LICENSEE: Southern Nuclear Operating Company
FACILITY: Joseph M. Farley Nuclear Plant, Units 1 and 2
SUBJECT: SUMMARY OF TELEPHONE CONFERENCE ON FEBRUARY 18, 2004,
BETWEEN THE U.S. NUCLEAR REGULATORY COMMISSION AND THE
SOUTHERN NUCLEAR OPERATING COMPANY CONCERNING DRAFT
REQUESTS FOR ADDITIONAL INFORMATION ON JOSEPH M. FARLEY
NUCLEAR PLANT, UNITS 1 AND 2, LICENSE RENEWAL APPLICATION
(TAC NOS. MC0774 AND MC0775)

REVIEW OF LICENSE RENEWAL APPLICATION (LRA) FOR FARLEY UNITS 1 AND 2 DRAFT REQUESTS FOR ADDITIONAL INFORMATION (D-RAIs)

**APPLICANT'S DRAFT RESPONSES TO
DRAFT REQUESTS FOR ADDITIONAL INFORMATION (D-RAIS)**

In response to the staff's request, Figure 2.3.4.4-1, "Turbine Driven AFW Pump Turbine Lube Oil Piping Schematic", was developed to identify the components of this subsystem and to present SNC's scoping results in accordance with the requirements of 10 CFR 54.4(a).

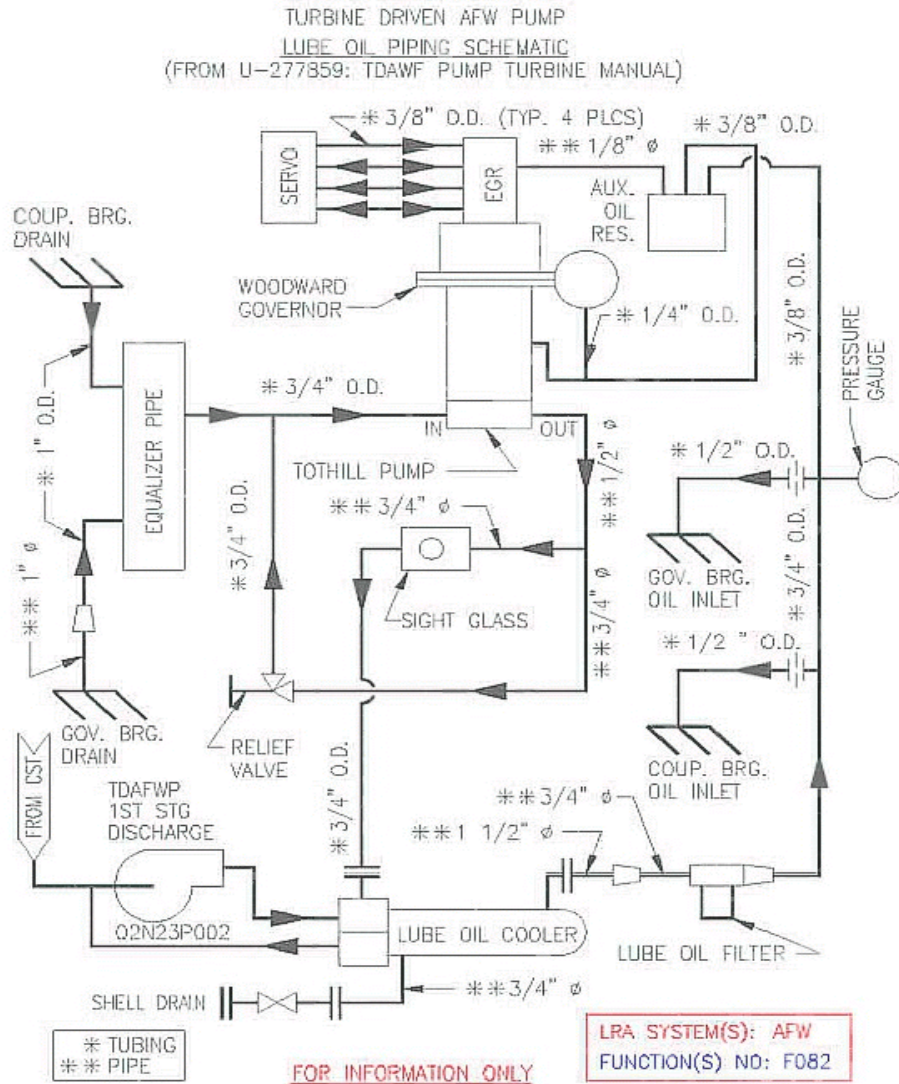
D-RAI 2.3.4.4-1

UFSAR Section 6.5.2.2.2 states that “Turbine bearings are lubricated by a forced feed lube oil system driven from the turbine shaft. Lube oil cooling water is supplied from the first stage of the auxiliary feedwater pump discharge and returned to the pump via the pump balancing line. This arrangement ensures a supply of cooled lube oil whenever the turbine is operating.” Since the AFW pump turbine drive must be operable for the AFW system to perform its intended function, the staff considers the turbine lube oil subsystem to be within the scope of license renewal.

LRA Table 2.3.4.4 lists the components of the AFW system that are subject to an AMR. Some items included are: Filters (casing), Oil Cooler (shell), Oil Cooler (channel head), Oil Cooler (tube sheet), Oil Cooler (tubes). These components comprise part of the turbine lube oil subsystem. The AFW pump and its turbine drive are shown on license renewal boundary drawings D-175007 and D-205007L (location H5 on both drawings) and also on D-175033L and D-205033L (sheet 2, location E3 on both drawings). However, the turbine lube oil subsystem and its components are not shown on these drawings.

Identify which cooling water system is used to cool the lube oil in the heat exchanger. Confirm that all components of the turbine lube oil subsystem (AFW system) are within the scope of license renewal and subject to an AMR in accordance with the requirements of 10 CFR 54.4(a) and 54.21(a)(1), respectively; or provide drawings which show the turbine lube oil subsystem and all of its components, and identify those components considered to be within the scope of license renewal and subject to an AMR.

Draft Response:

Component Type	Intended Function
Closure Bolting	Pressure Boundary
Filters (casing)	Pressure Boundary
Flow Orifice/Element	Flow Restriction Pressure Boundary
Oil Cooler (shell)	Pressure Boundary
Oil Cooler (channel head)	Pressure Boundary
Oil Cooler (tube sheet)	Pressure Boundary
Oil Cooler (tubes)	Exchange Heat Pressure Boundary
Piping	Pressure Boundary
Pump Casings	Pressure Boundary
Sight Glasses	Pressure Boundary
Tanks (Auxiliary Oil Reservoir)	Pressure Boundary
Valve Bodies	Pressure Boundary

Three of the component types listed - "Flow Orifice/Element", "Sight Glasses", and "Tanks" - were not included in the LRA as part of the Turbine Driven AFW Pump Turbine Lube Oil Subsystem of the AFW System. These component types were identified during the development of this response. The "Sight Glasses", and "Tanks" component types and associated intended functions should have been included in Table 2.3.4.4 of the LRA (the "Flow Orifice/Element" component type is already in the table). Aging management reviews for these components were performed.
